**Committee of the Whole Report** For the Meeting of October 6, 2022

Subject:	Rezoning Application No. 00820 and Deve Application No. 00207 for 722 and 726 Disco	•
From:	Karen Hoese, Director, Sustainable Planning a	nd Community Development
То:	Committee of the Whole	Date: September 22, 2022

MjH SHEET TITLE ORIGINAL SIZE 60.96cm x 91.44cm (24" x 36") SEALED DESIGN BY TREE REPLACEMENT & STORMWATER AREA PLAN DRAWN BY LN CHECKED BY MjH PROJECT # RE-ISSUED FOR DEVELOPMENT PERMIT 211-01841-00 SHEET NO. MjH ISSUED FOR PRELIMINARY DEVELOPMENT SCALE PERMIT L-01 DESCRIPTION BY 1:100

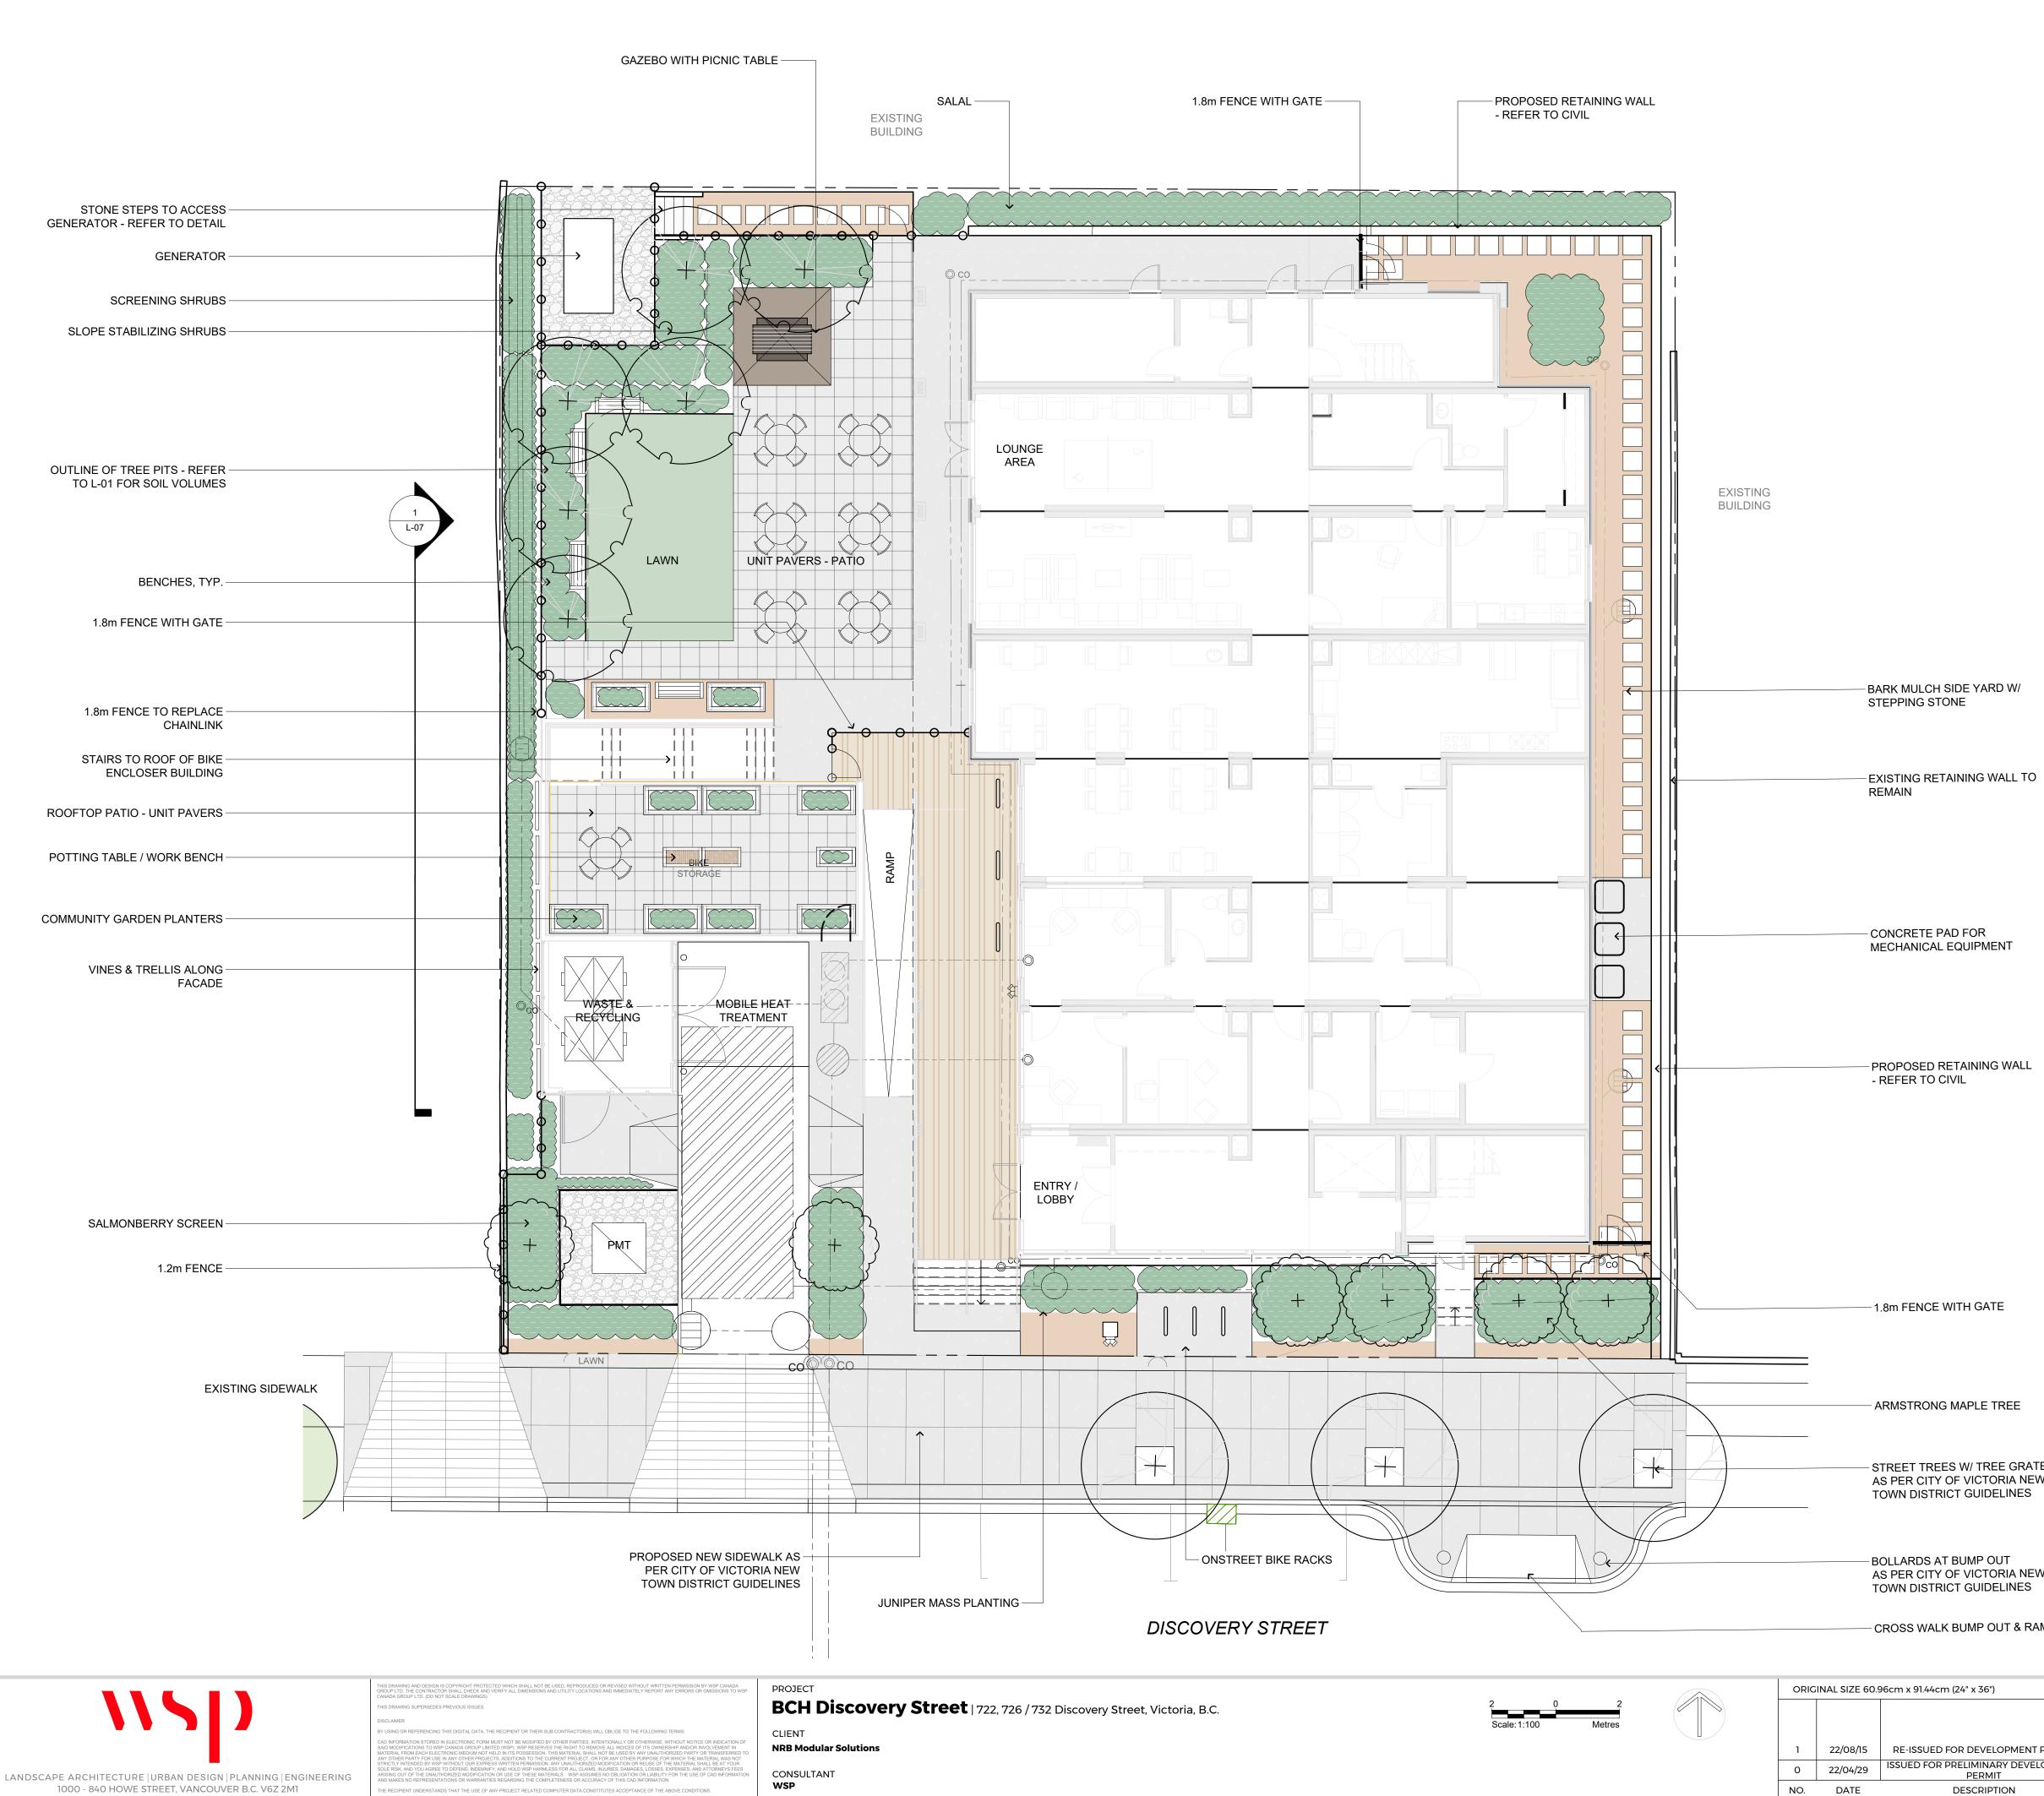
However, it is worth noting that the tree soil volumes and siting requirements outlined in the *Tree Protection Bylaw* have not been met on the plans. It is recommended for Council's consideration that the application meets the tree soil volumes and siting requirements as a condition of rezoning.

The inventory in the Arborist Report does not account for all the bylaw-protected trees on the subject properties. There is a total of eight bylaw-protected trees on the subject property as well as two smaller yew plants, which may be bylaw-protected Pacific yews. Confirmation of species will be required in accordance with the *Tree Protection Bylaw*.

The proposed plans currently show one municipal tree, a 38 cm DBH Field elm, as removed; however, the arborist report and staff recommend the retention of this tree. Along the Discovery frontage, there are three large bylaw-protected Garry oak trees (87cm, 87cm and 74cm DBH), and one small 100cm tall, bylaw-protected Garry oak seedling on the subject lot. The application proposes to remove all four Garry oaks and replace them with medium or small canopy trees at maturity. The proposed placement of the new trees does not meet the *Tree Protection Bylaw* soil volumes or siting, and therefore, they will not count towards replacement trees or the tree minimum.

- b. revise the site plan and landscape plan to comply with the tree identification, soil volume and tree replacement requirements in accordance with the Tree Protection Bylaw to the satisfaction of the Director of Parks, Recreation and Facilities.
